SERVICE PARTS LIST

SPECIFY CATALOG NO. AND SERIAL NO. WHEN ORDERING PARTS		REVISED BULLETIN	DATE
7" GRINDER			Aug. 2007
CATALOG NO.	6088-20	SERIAL NUMBER	994A
		WIRING INSTRUCTION 58-01-1370

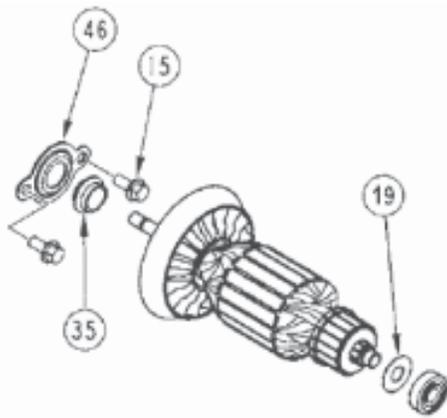
Milwaukee is providing a **no-charge** warranty service to all owners of **6086-20, 6088-20 and 6089-20 7"/9" Grinders**. We are taking this action because under certain circumstances the **'lock-on' Trigger Switch** can stick in the 'ON' position, which poses a risk of injury or property damage.

The original equipment switch (23-66-2710 / 23-66-2720) should be replaced with a new re-worked 23-66-2720. Reworked switches will have a white dot (indelible paint) applied to the location at the base of the switch (see illustration).

For operator safety a **6086-20, 6088-20 or 6089-20 7"/9" Grinder** within the listed serial number ranges should be returned to the nearest **factory** Service/Sales Support Branch or Milwaukee Authorized Service Station for a no-charge warranty replacement of the trigger switch.

If the nameplate has an **'X'** stamped into the tool's nameplate, next to the serial number, the tool has been repaired and the defective switch has already been replaced.

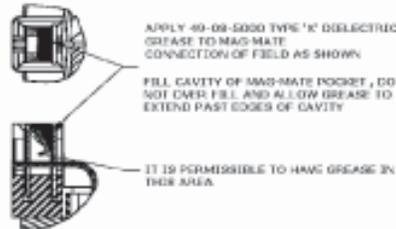
31-50-1752 Motor Housing Kit incorporates changes to the shielding of the armature pinion and commutator ball bearings along with the retaining of the pinion ball bearing into the gearcase assembly of 7"/ 9" 15Amp Sander / Grinders - 6080-20, 6081-20, 6082-20, 6086-20, 6088-20 and 6089-20.

Additionally, a change has been made to the motor housing and wiring of the tool. The ATF field coil is now 'hard-wired' with four [4] new leadwire assemblies, see **Wiring Instruction 58-01-1371**. Add 'X' Grease, 49-08-5000 to mag-mate field terminals as need.

Caution! Do Not overfill the cavity, excess grease can cause a build up of dust / dirt and result in a possible 'shorting-out' or burning at the connection.

Motor Housing Kit consist of:	Discarded Parts:	Model Affected
2ea 06-75-0510 ¼-20 Hex Screw* <i>item 15</i>		All
1ea 45-06-0830 Bearing Seal <i>item 19</i>		All
1ea 31-50-1785 Motor Housing <i>item 26</i>	31-50-1751 Motor Housing	All
1ea 31-53-0160 Plug**	31-53-0160 Plug*	All
1ea 31-55-0290 Dust Shield <i>item 35</i>		All
1ea 44-86-0040 Bearing Retainer ^A <i>item 46</i>	44-66-2100 Bearing Ret Plate	All
1ea 23-94-9300 LeadWire Assembly	23-94-2650 LeadWire Assy	All
1ea 23-94-9305 LeadWire Assembly	23-94-2655 LeadWire Assy	All
1ea 23-94-9310 LeadWire Assembly		All
1ea 23-94-9315 LeadWire Assembly		All
	42-96-0145 Bearing Cup	All

* Torque 06-75-0510 to 65-75 in-lbs.

** running change, part modified without part number change - two wire traps added - part must have a total of 4 wire traps
